# **DR / DR-x MDI: Support for Breakout (Comments #341 and #342)**

**IEEE P802.3dj Task Force  
Optical / Logic Ad hoc Meeting  
29 August 2024**

Figure 180-7—400GBASE-DR2 optical lane assignments

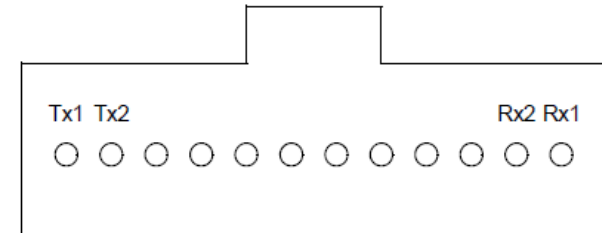
- **Mapping DR2 and DR4 MDI lane assignments to the same connector**
- **For both assignments**
  - **Only single port of target PHY defined**
  - **Lower lane count PHYs could be supported**
- **Multiple PHY types could be mapped to the same connector in different configurations**

Figure 180-9—1.6TBASE-DR8 optical lane assignments

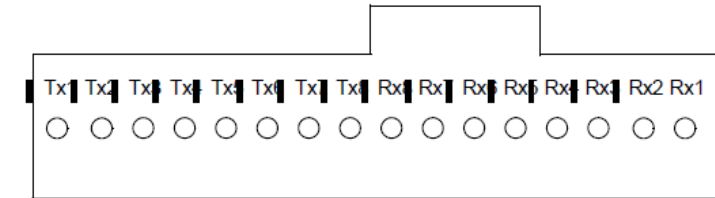
- **Only single port of target PMD implemented**
- **Multiple PHY types could be mapped to the same connector in different configurations**

Figure 182-7—400GBASE-DR2-2 optical lane assignments

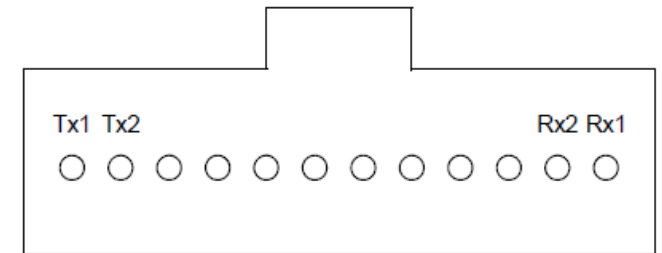
- **Mapping DR2-2 and DR4-2 MDI lane assignments to the same connector**
- **For both assignments**
  - **Only single port of target PHY defined**
  - **Lower lane count PHYs could be supported**
- **Multiple PHY types could be mapped to the same connector in different configurations**

Figure 182-9—1.6TBASE-DR8 optical lane assignments

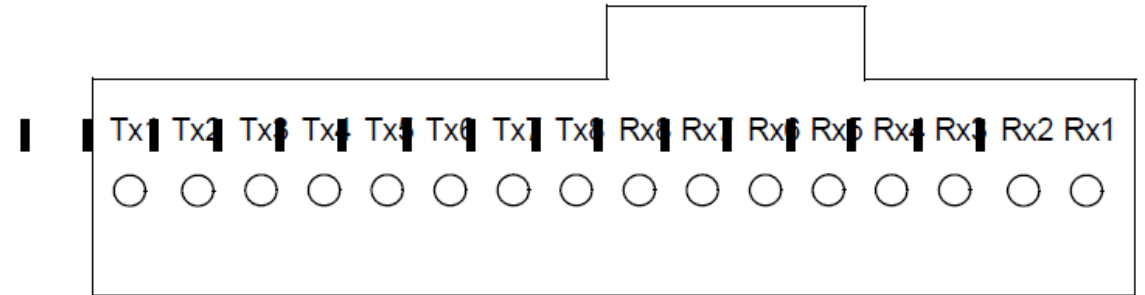
- **Only single port of target PMD implemented**
- **Multiple PHY types could be mapped to the same connector in different configurations**
- **Note – Caption to Fig 182-9 is incorrect – it should be 1.6TBASE-DR8-2**
